Appeal NO: ABP 314485

Bord Pleanála Case Number: ABP-314485-22

Planning Authority Case Reference: F20A/0668

Observations relating to Bord Pleanála Case reference ABP-314485-22 subsequent to the receipt of additional information from daa.

Actual 28R Departure tracks overlaid on 28L Missed approach

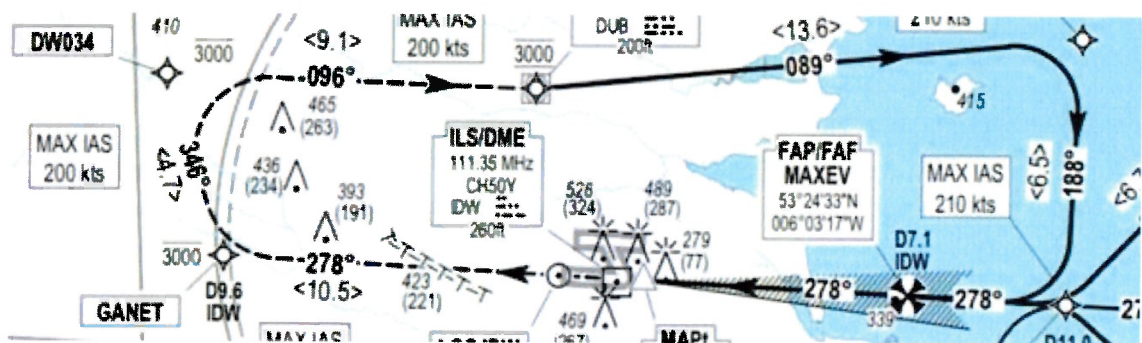
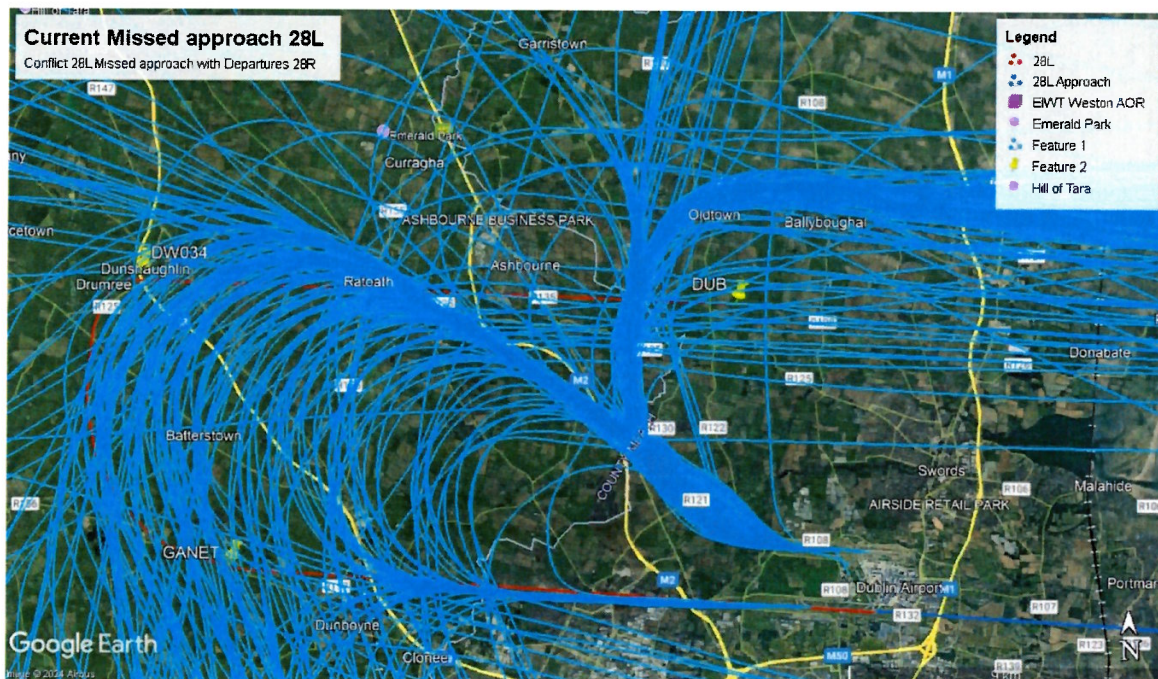
As you can see on the first chart above, the missed approach off 28L tracks North and then east towards the Dublin VOR.. (*Departure tracks not shown on this chart.*)

The second Picture is actual radar flight data of all departures for one 24 hour period.. In red you can see the missed approach track off 28L.

The red missed approach altitude is 3000ft. Where these two intersect, departing aircraft have been tracked between 2800ft and 4000ft. This is clearly a conflict. So how do ATC avoid the risk of collision?

If an aircraft performs a missed approach off 28L, all departures are stopped off 28R. Remember the definition of Independent operations is that the operation of one runway has no effect of the other parallel runway? This is clearly not the case in Dublin Airport.

Actual Missed approach observed.

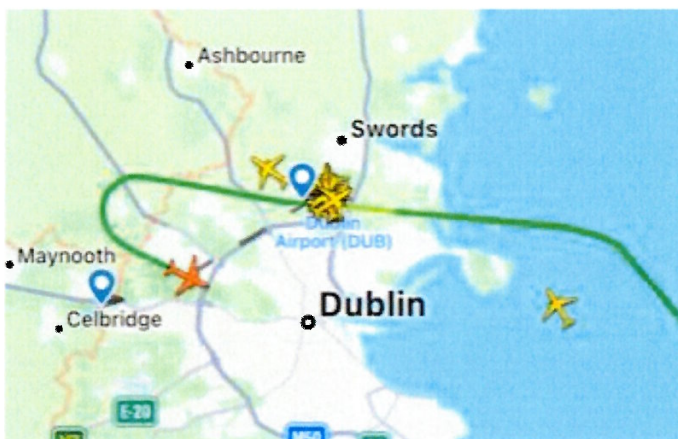
When an aircraft performs a missed approach, Dublin Airport becomes a Dependent operation. In this mode 30 degree turns off the North runway are not required.

So, What happens to an aircraft on approach to 28L that performs a missed approach? The aircraft is turned left over Dublin City, a procedure that AIR Nav stated is complicated to design, and cannot be done.

The reason that in the picture above where we have Radar tracks for departures, but a drawn in procedure for the missed approach, is because since the opening of the North Runway in August 2022, not one single aircraft performing a missed approach has flown the published procedure.
